| Project Title: | Mission Rock Energy Center |
| Document Title: | Data Request Responses Set 1 & 1A to Data Requests 1 through 114 |

Responses to California Energy Commission Staff
Data Requests 1 through 114

Mission Rock Energy Center

Attachment DR23-1 Riparian Habitat Map

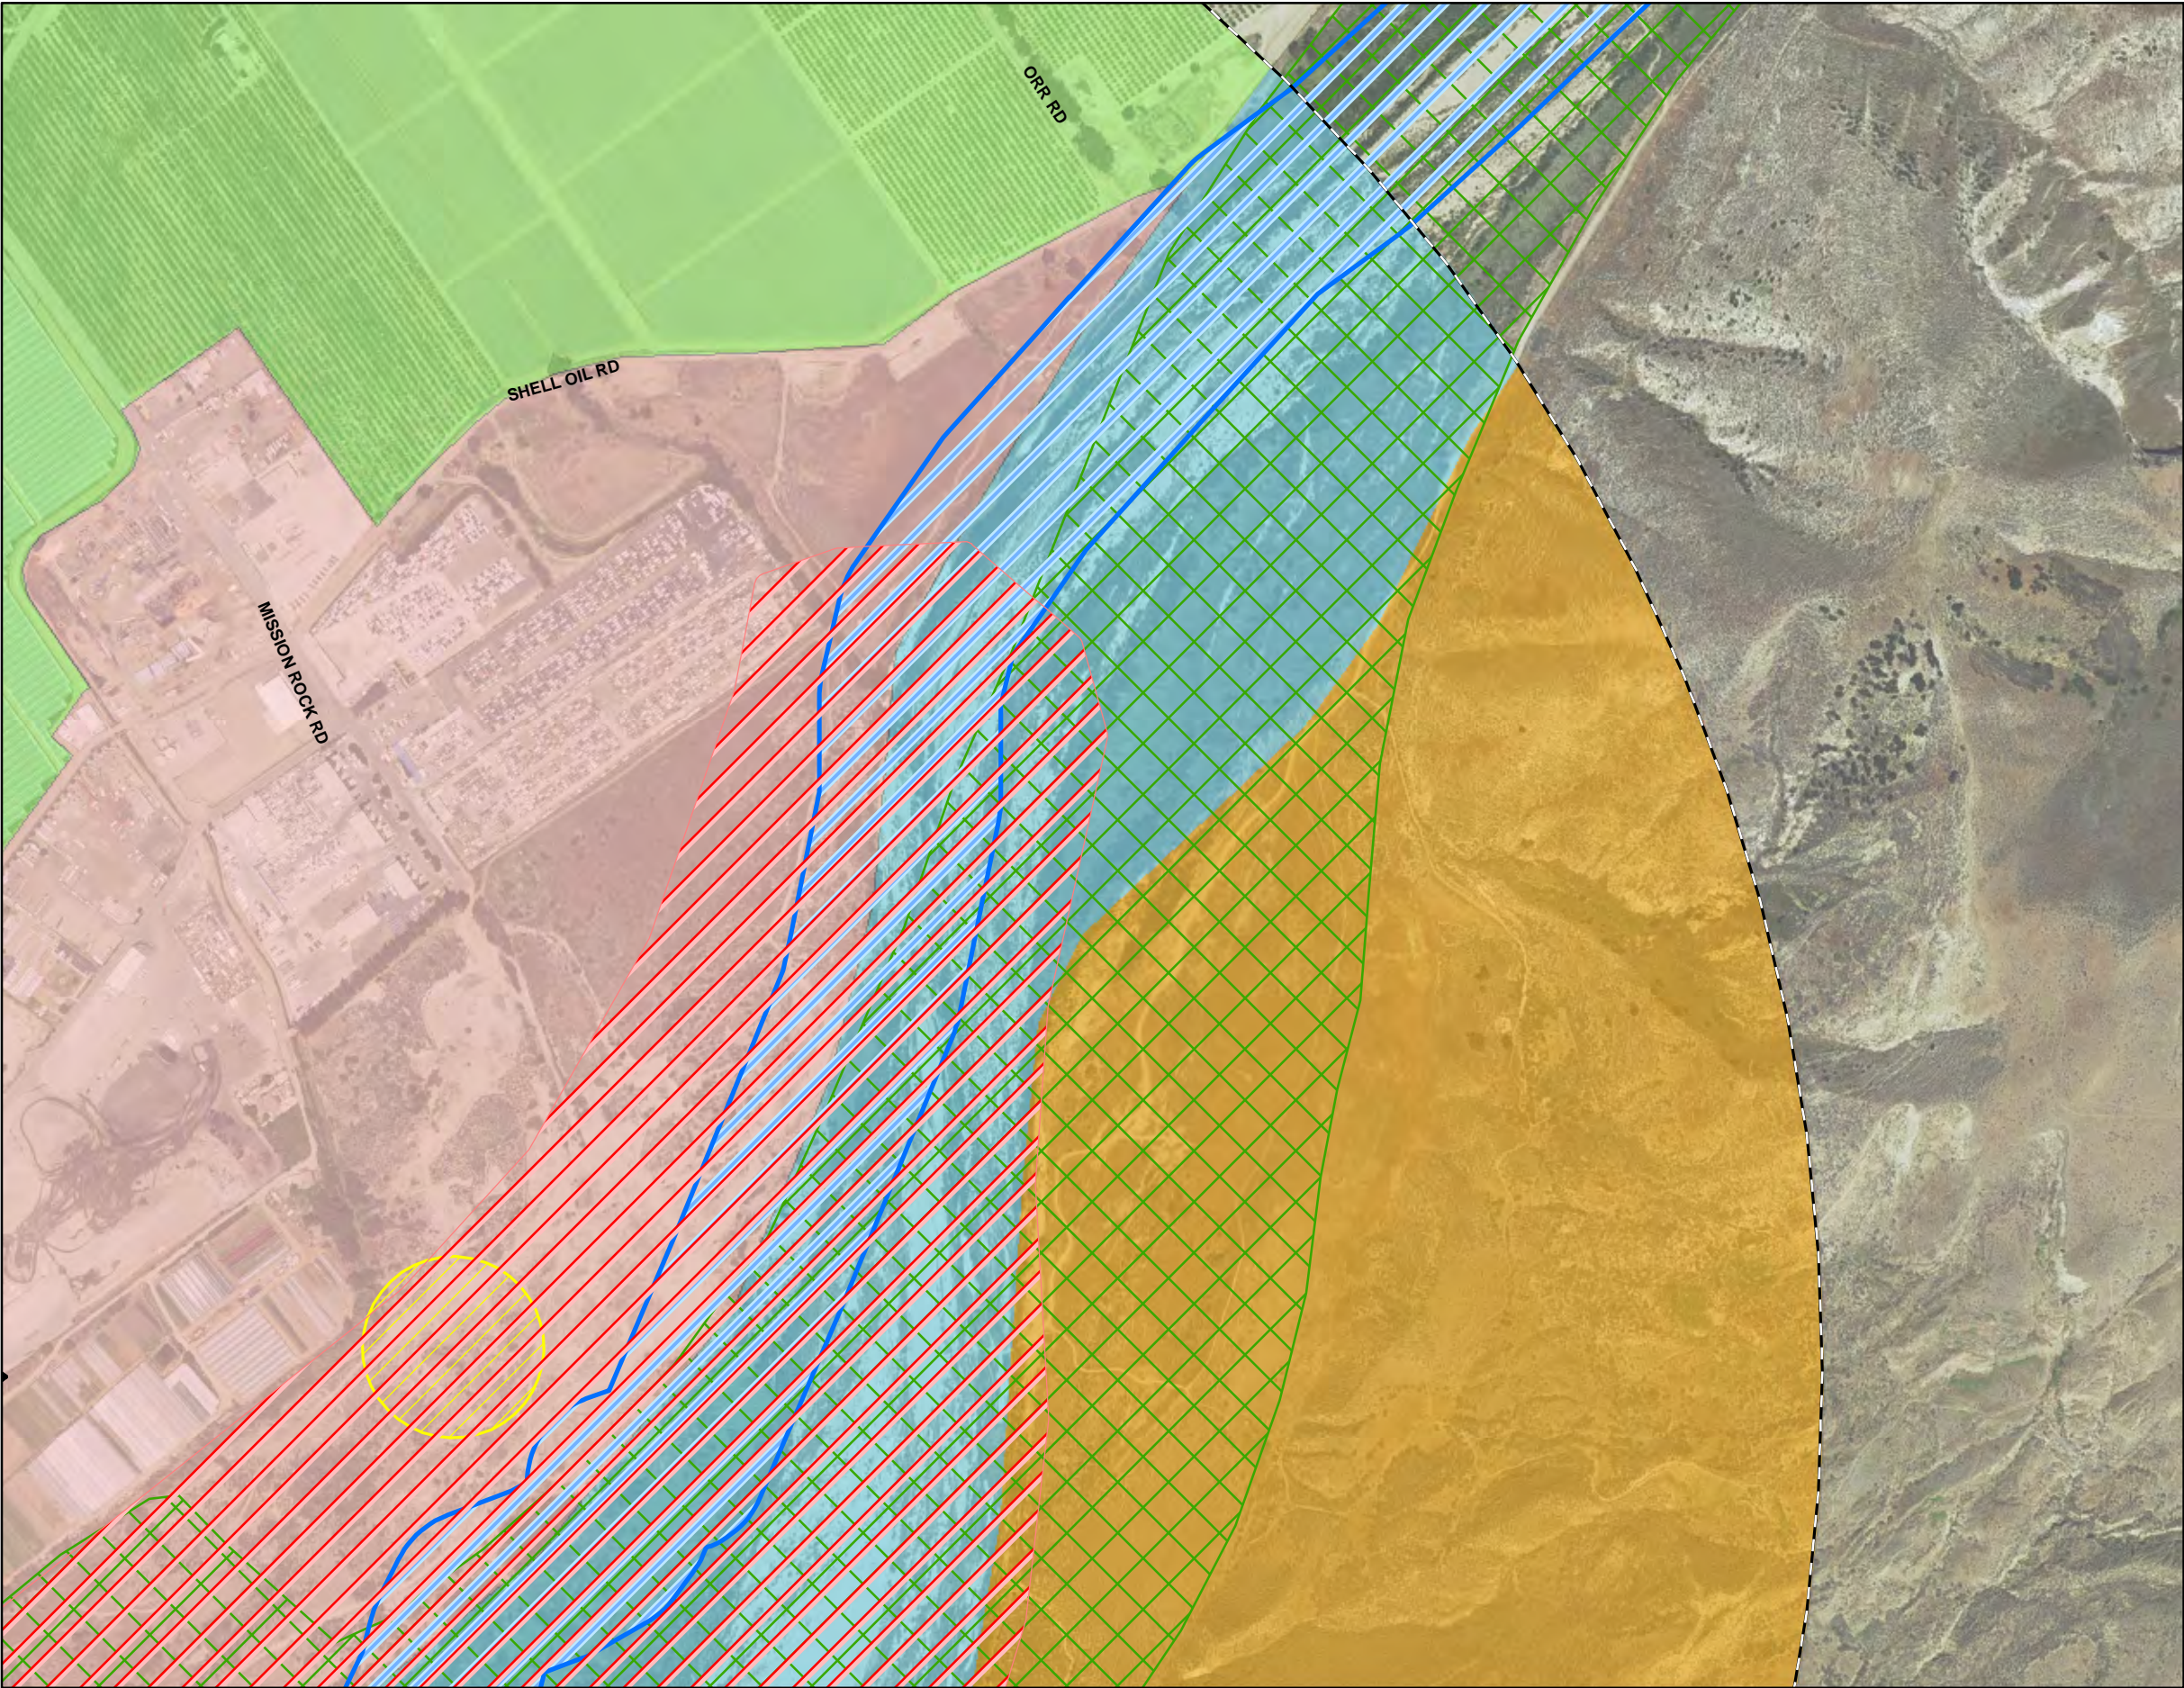
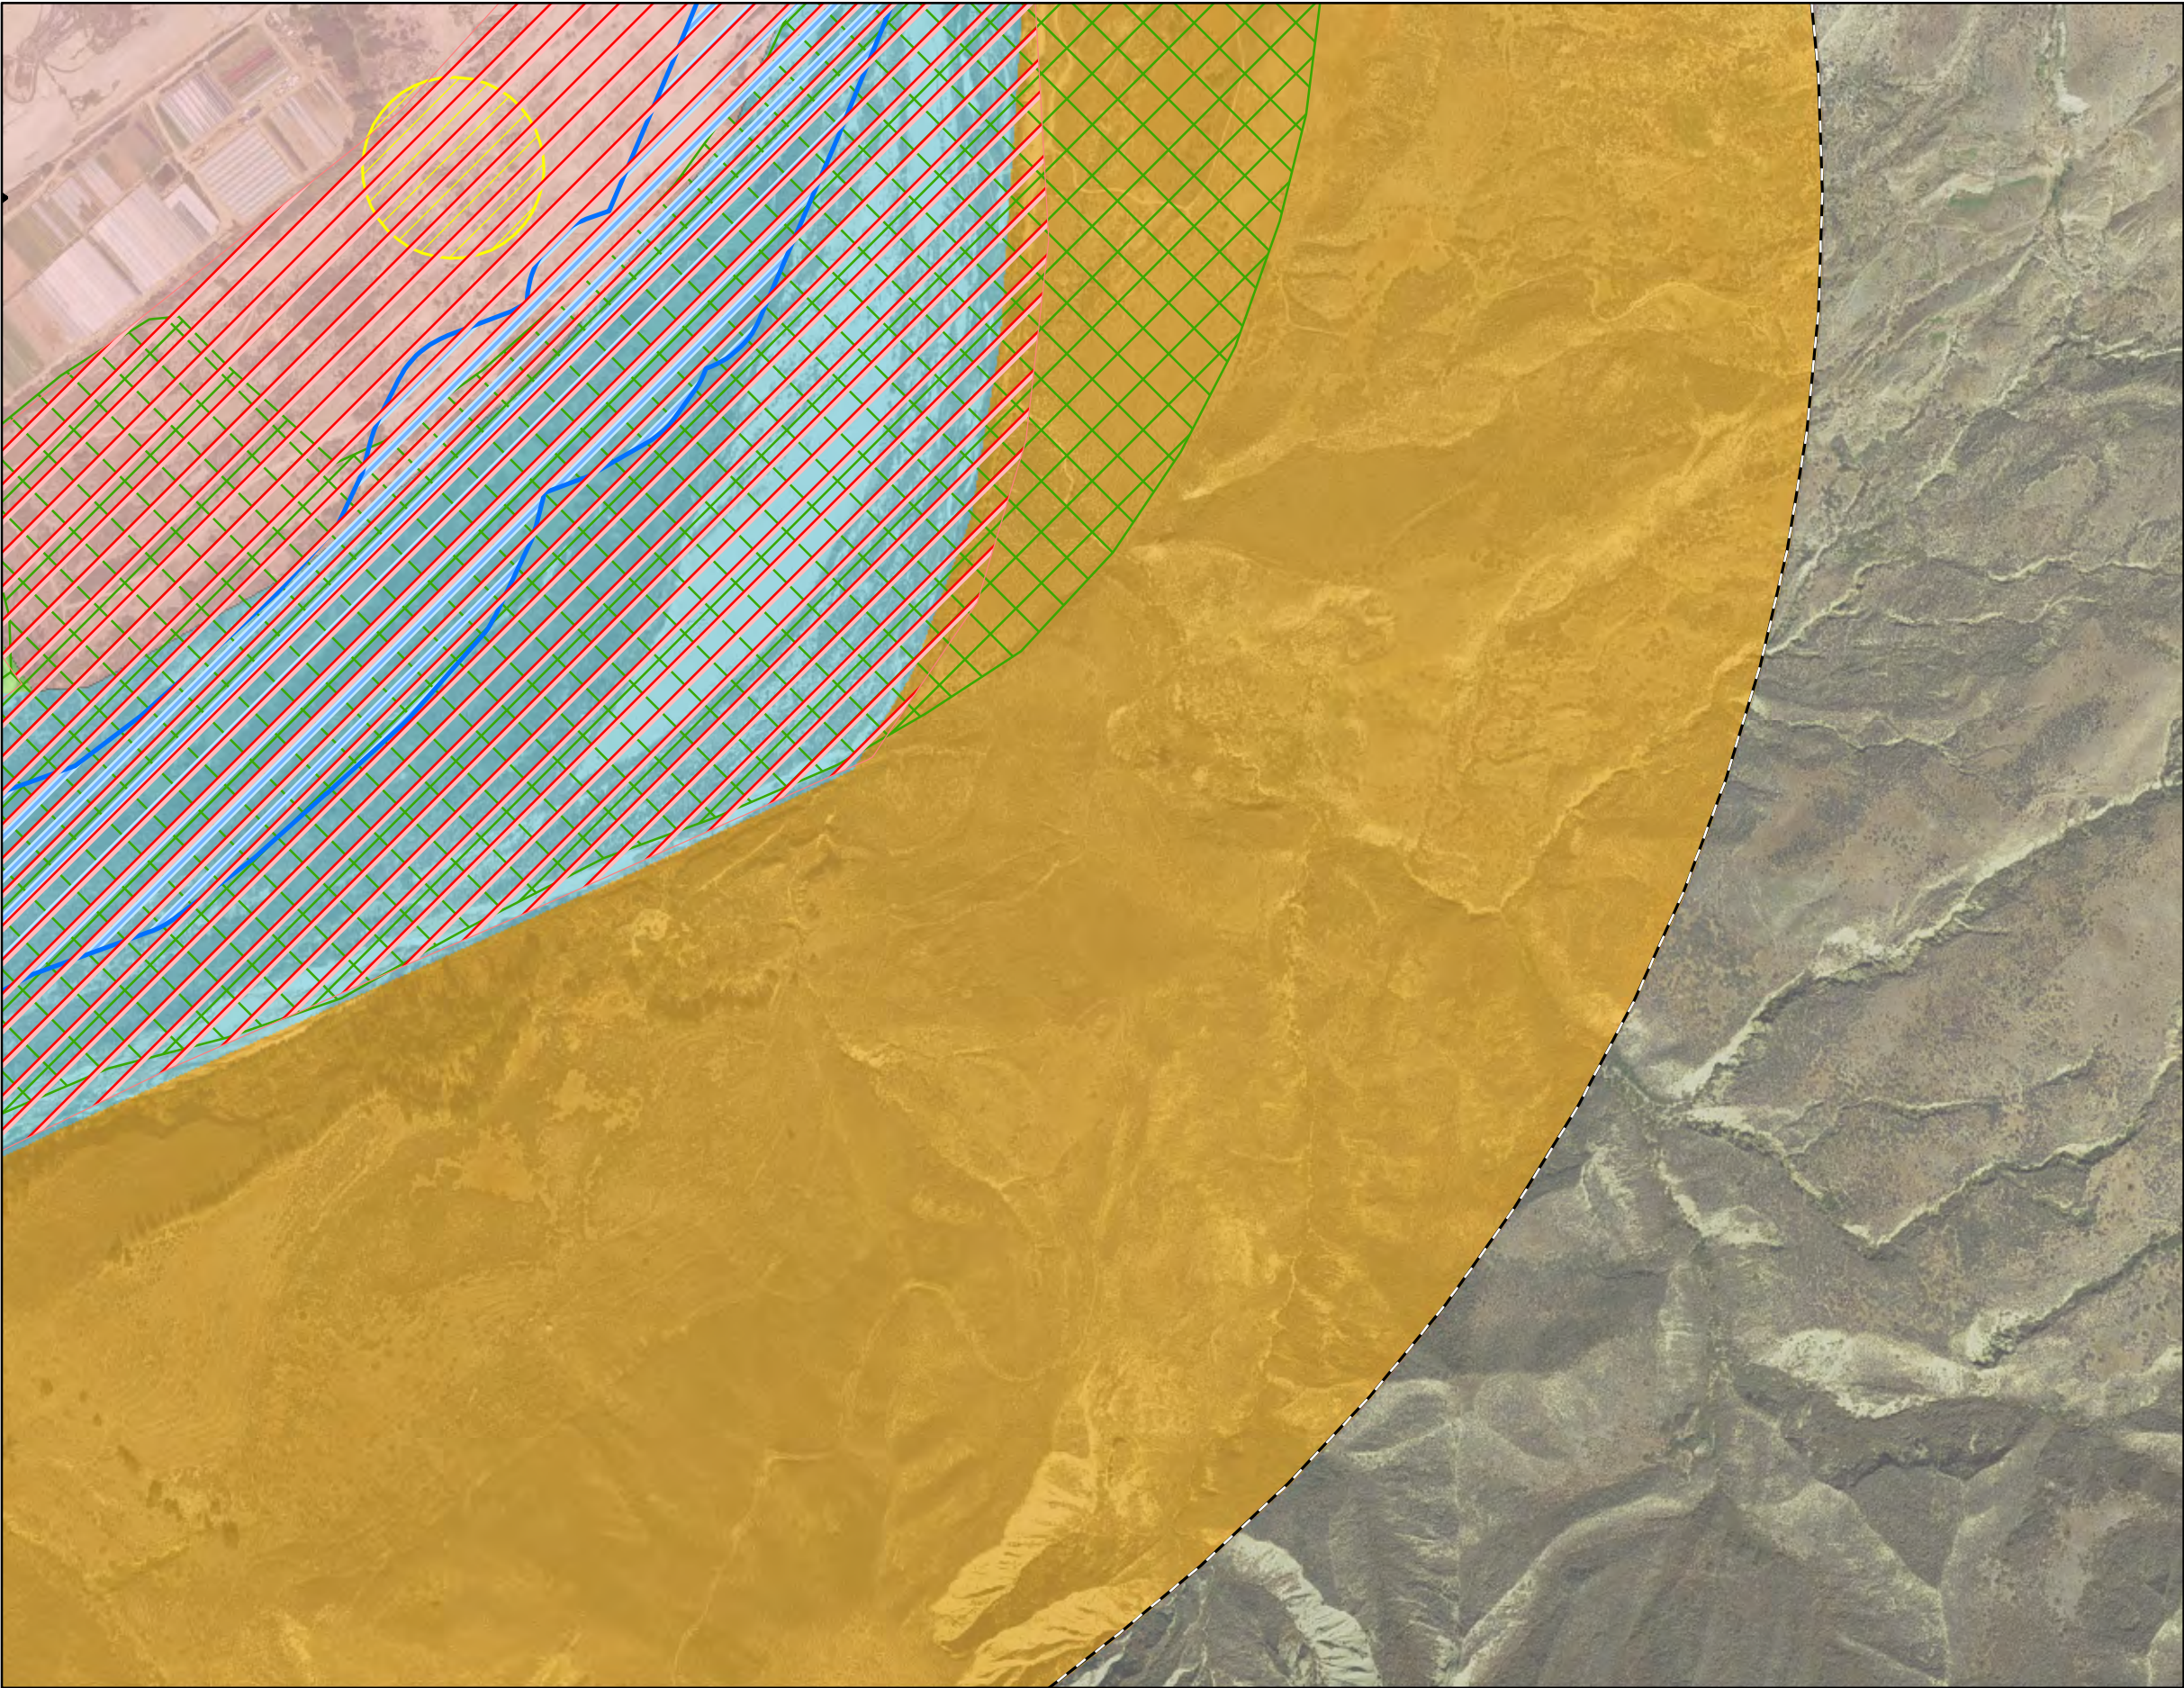
23. *Please revise Figure 5.2-6 to show the areas of riparian habitat.*

Response: Figure DR23-1, showing riparian habitat areas, is attached.
